Subject: Almond 2 Power Plant (09-AFC-02)
Supplement A - Data Adequacy Responses

DATA ADEQUACY SUPPLEMENT A

Response to Data Adequacy Review

Almond 2 Power Plant

**FIGURE DA5.15-1
LOCATION OF THE TID
IRRIGATION CANAL**
ALMOND 2 POWER PLANT
CERES, CALIFORNIA

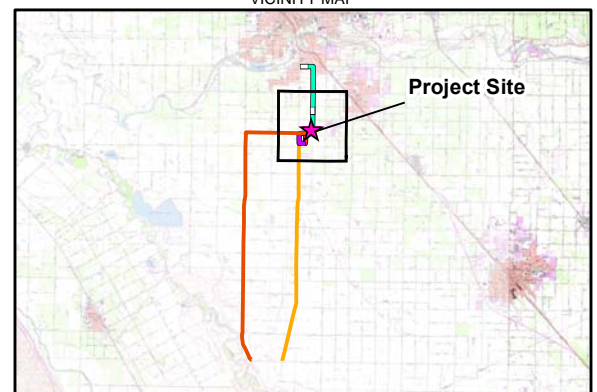
Information required to make AFC conform with regulations:

Section 5.15.1.4.3 identifies the TID Irrigation Canal, a surface water body, south of the A2PP Site. Identify the location of the canal on an appropriate map or provide a more detailed description of its location and distance from the site.

Section 5.15.1.4.3 and Section 5.15.2.1.3 describe that "TID Irrigation Canal water may be used for construction activities." Describe the conveyance method to be used to bring the canal water to the site.

Response: Figure DA5.15-1 identifies the location of the TID irrigation canal.

Response: If water from the TID irrigation canal located to the south of the project site (Figure DA5.15-1) is used for construction purposes, a portable pump would be used to transfer the water through hoses into a water truck. The water truck would then transport the water to the project site for construction use. All activities associated with the transport of water from the TID irrigation canal to the project site would occur on TID-owned land.
